REPLACEMENT OF THE WATER PUMP 65500 WITH 65569 FOR RENAULT CLIO

TECHNICAL INFO NO. 1047

Fig. 2: New water pump 65569

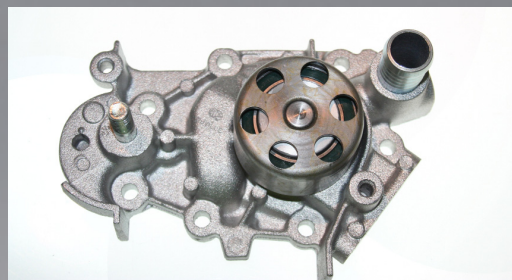
Similarly to the vehicle manufacturer, Ruville has replaced water pump 65500 (Fig. 1) with water pump 65569 (Fig. 2).

During the changeover period, it is possible for mixed stocks of both versions to occur. Both versions comply with the technical requirements and can be put to unrestricted use for the vehicles stated in the catalogue media.
